Subject: Arkansas Nuclear One – Units 1 and 2  
Docket Nos. 50-313 and 50-368  
License Nos. DPR-51 and NPF-6  
Additional Information Regarding Condensate Storage Tank Volume  
Technical Specification Changes (TAC NOS. MA8206 and MA8207)

**Response to NRC RAIs on ANO CST License Amendment Request**

Figure 1  
 ANO - 1 Simplified Drawing

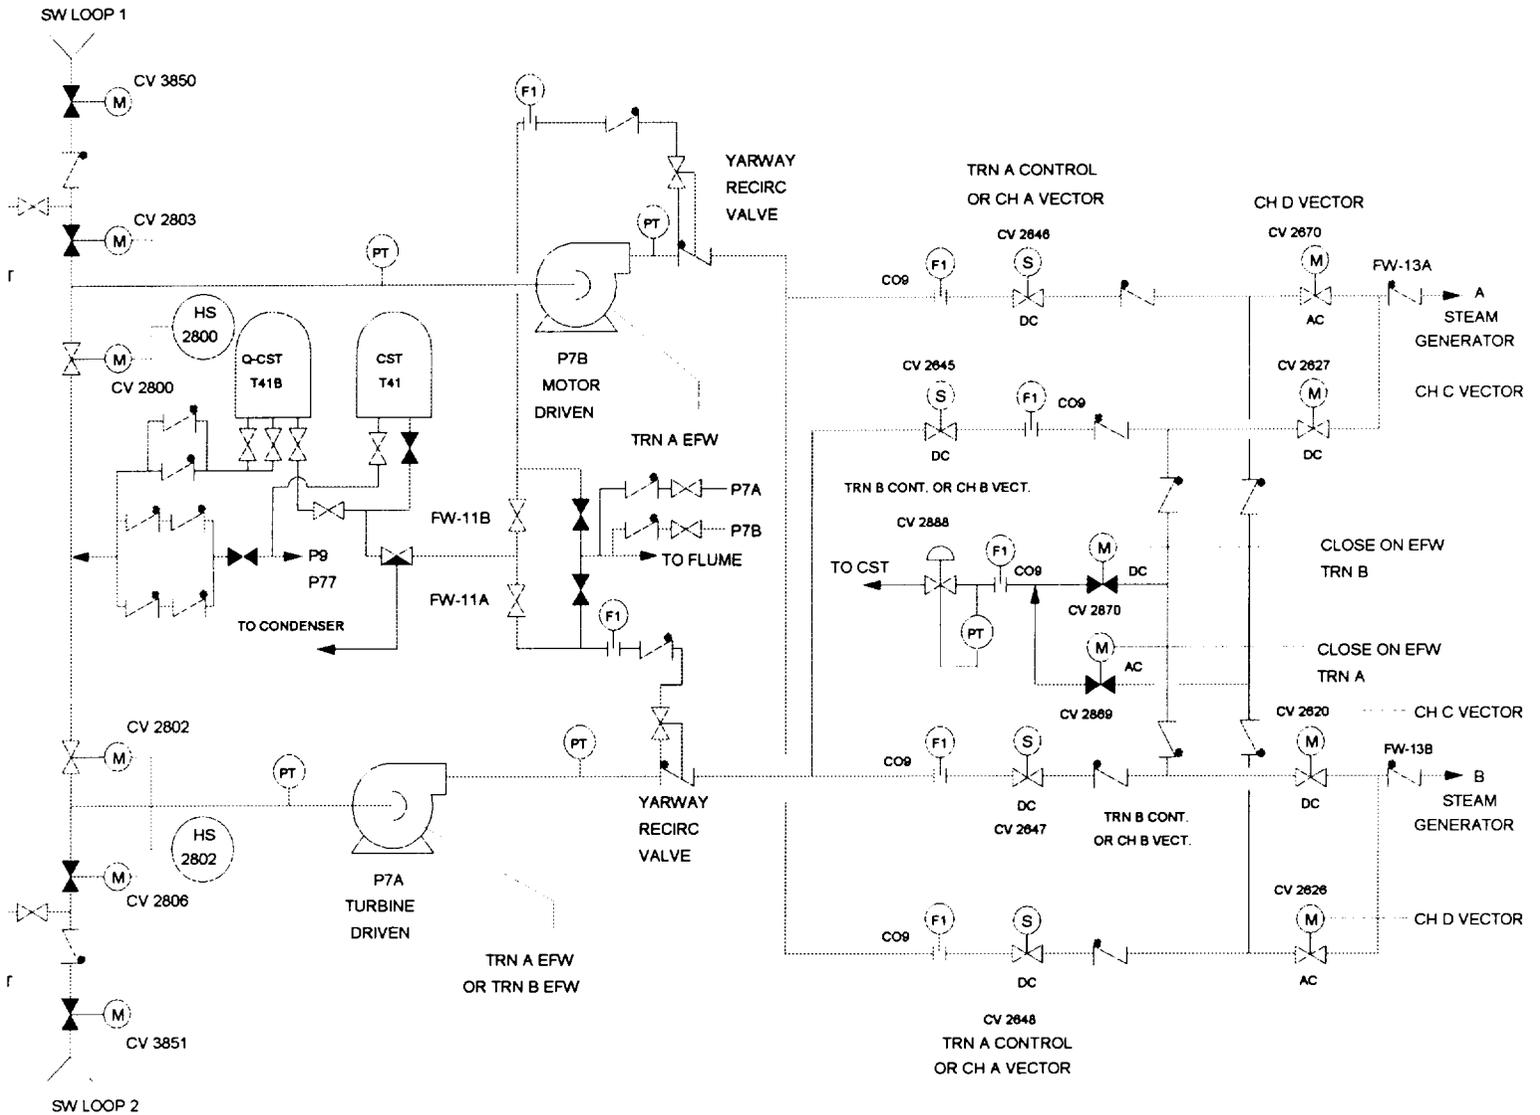
Are the valves needed to realign the source of auxiliary feedwater systems to the service water systems tested to demonstrate that they will be capable of performing their intended function? How often are they tested?

Water from either CST is aligned to the suction of each pump through an 8" motor operated gate valve. Water supply to P-7A is isolated by CV-2802 while CV-2800 isolates water to P-7B. These isolation valves are located in the EFW pump room and are normally open. These valves are stroked closed and open each quarter using Supplement 3, Emergency Feedwater Valve Stroke Testing, of 1106.006.

SW loop 2 supplies P-7A through motor operated valve (MOV) CV-3851 and suction supply isolation CV-2806. SW Loop 1 supplies P-7B through motor operated isolation valve CV-3850 and suction supply isolation CV-2803. SW loop and suction supply isolations to EFW are normally closed. These valves are stroked open each quarter using instructions contained in Supplement 3 of 1106.006.

Figure 1 shows that closure of CV-2802 and opening of CV-2806 and CV-3851 will align service water to P-7A. To align service water to P-7B, CV-2800 is closed and CV-3850 and CV-2803 are opened. No other valve manipulations are required.

Figure 2  
 ANO - 2 Simplified Drawing

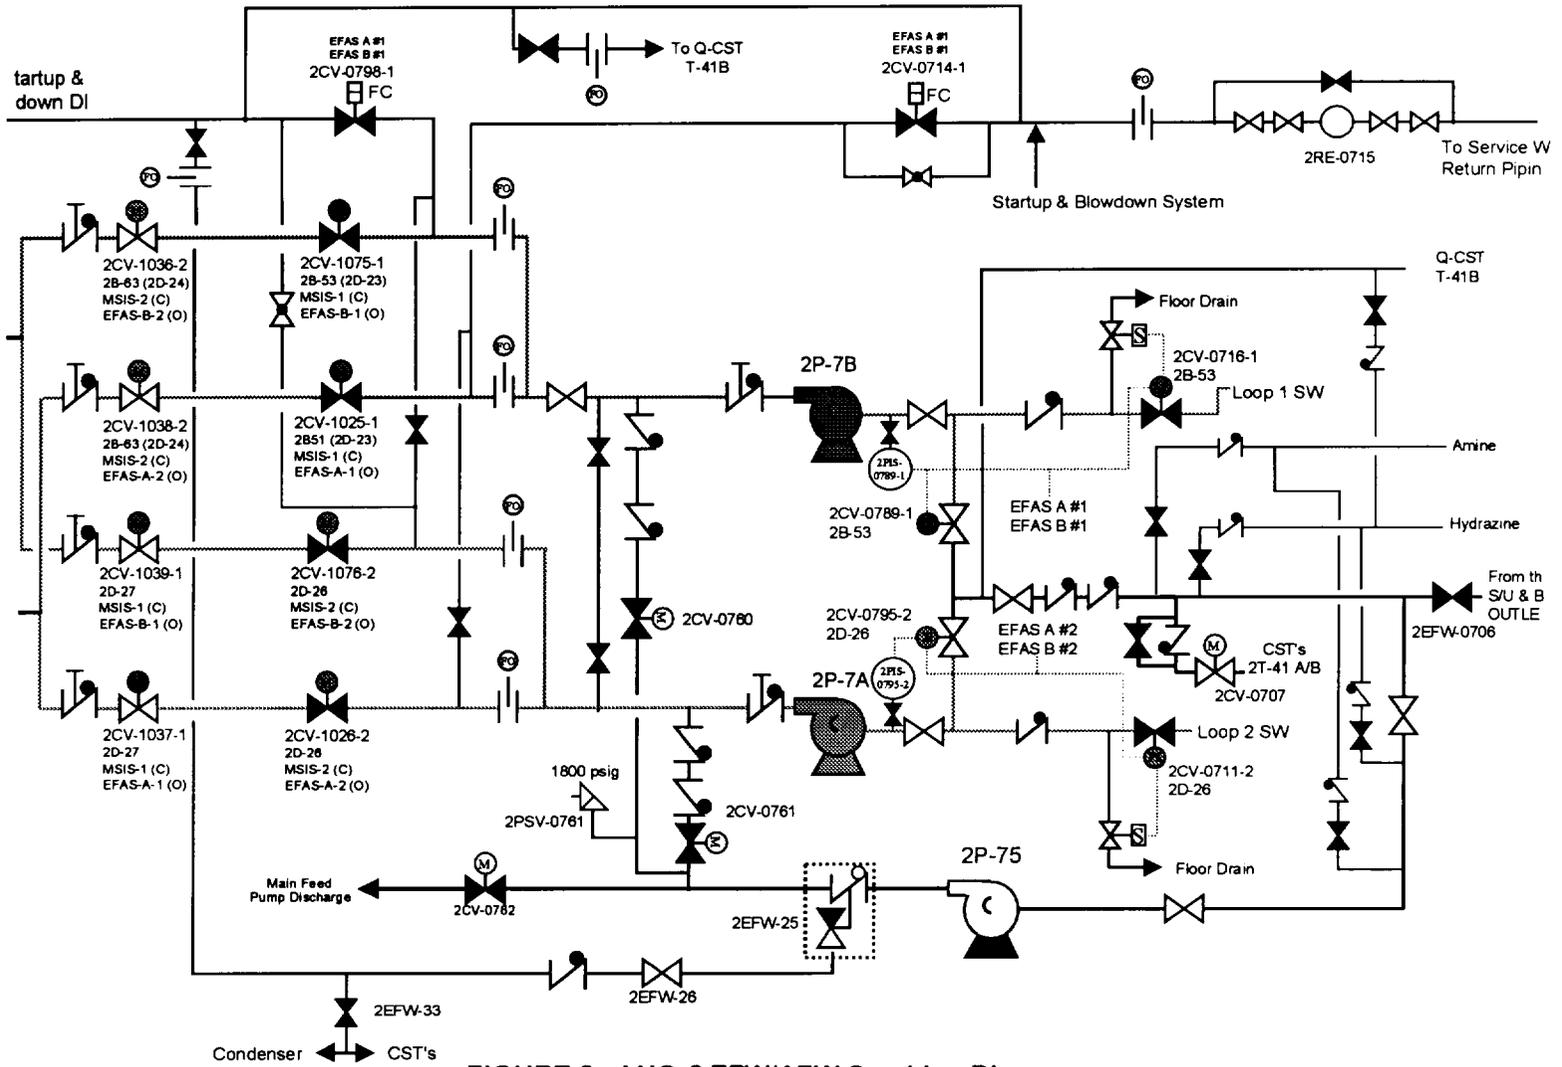
Are the valves needed to realign the source of auxiliary feedwater systems to the service water systems tested to demonstrate that they will be capable of performing their intended function? How often are they tested?

As the attached ANO-2 emergency feedwater simplified system drawing (Figure 2) reflects, opening 2CV-0716-1 and 2CV-0711-2 will align service water to the suction of the EFW pumps and closure of two MOVs (2CV-0798-1 and 2CV-0795-2) will isolate suction from either the QCST (T-41B) or the ANO-2 CSTs (2T-41A or 2T-41B). The hand switches for these valves are located on panels in the Unit 2 control room. These valves are stroke tested quarterly using instructions contained in Supplement 3, Quarterly Emergency Feedwater Valve Stroke Testing. 2CV-0716-1 and 2CV-0711-2 are stroked open and 2CV-0798-1 and 2CV-0795-2 are stroked in the open and closed directions.
